SUBJECT: SURRY UNITS 1 AND 2 - ISSUANCE OF AMENDMENTS RE: CONTROL ROD
ASSEMBLIES AND SURRY IMPROVED FUEL (TAC NOS. 63166, 63167,
65432, 65433, 65561 AND 65562)

Amendment No. 116
License No. DPR-32

Amendment No. 116
License No. DPR-37

SAFETY EVALUATION BY THE OFFICE OF NUCLEAR REACTOR REGULATION
RELATED TO AMENDMENT NO. 116 TO FACILITY OPERATING LICENSE NO. DPR-32
AND AMENDMENT NO. 116 TO FACILITY OPERATING LICENSE NO. DPR-37
VIRGINIA ELECTRIC AND POWER COMPANY
SURRY POWER STATION, UNIT NOS. 1 AND 2
DOCKET NOS. 50-280 AND 50-281

FIGURE 3.12-1A CONTROL BANK INSERTION LIMITS FOR 3-LOOP
NORMAL OPERATION-UNIT 1

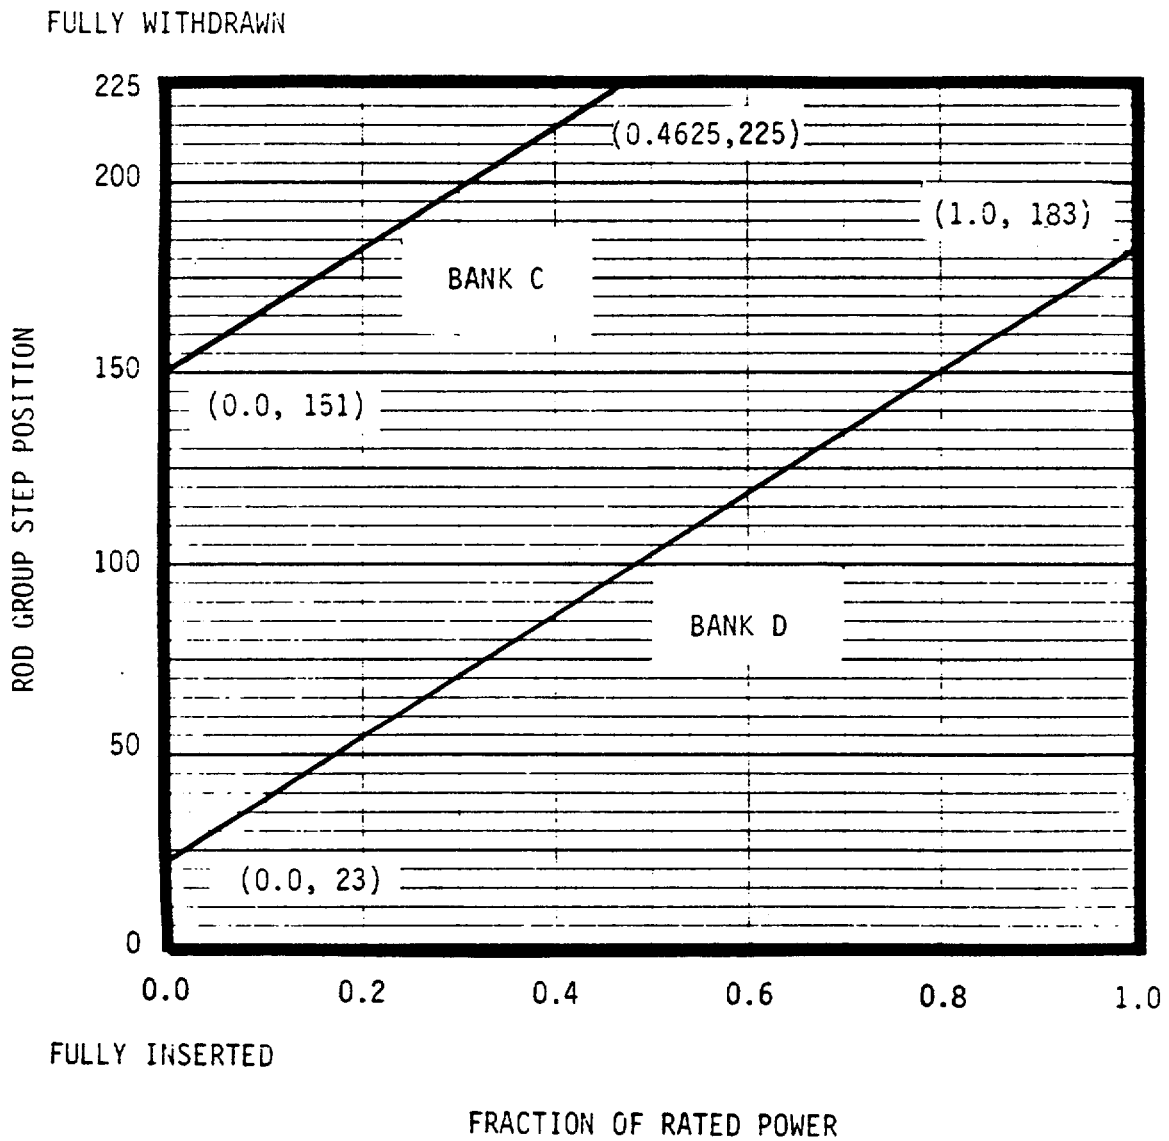
By letter dated April 1, 1987, the licensee requested to revise Figures 3.12-1A and 3.12-1B of the Surry TS, which govern the control rod insertion limit. The licensee proposed redefining the fully withdrawn position of all rod cluster control assembly (RCCA) banks to 225 steps, instead of the current 228 steps. The change will allow greater operational flexibility with regard to control rod bank positioning as a means of minimizing localized RCCA wear.

By letter dated April 1, 1987, the licensee proposed to redefine the fully withdrawn position of all RCCA banks to 225 steps, which would eliminate localized RCCA wear at the top of the control rods. The current fully withdrawn position is 228 steps. At 225 steps withdrawn, the RCCAs are only 0.31 inches into the active fuel region (228 steps withdrawn is above the active fuel region). Since the top region of the core has such low worth, the effect of the proposed change was expected to be minimal. To confirm this, neutron calculations were performed by the licensee.

The shutdown margin calculations showed a 0.003% $\Delta\rho$ decrease at beginning-of-life (BOL) and a 0.006% $\Delta\rho$ decrease at end-of-life (EOL) (recent cycles have excess shutdown margin of approximately 1.75% $\Delta\rho$ at BOL and 1.6% $\Delta\rho$ at EOL). The changes in the other parameters which would be affected are similarly minimal with respect to available margins.

Because the proposed change will result in slight insertion of the RCCAs into the active fuel region, the staff expects essentially negligible effects due to the proposed change. Therefore, the staff concludes that the proposed change is acceptable.
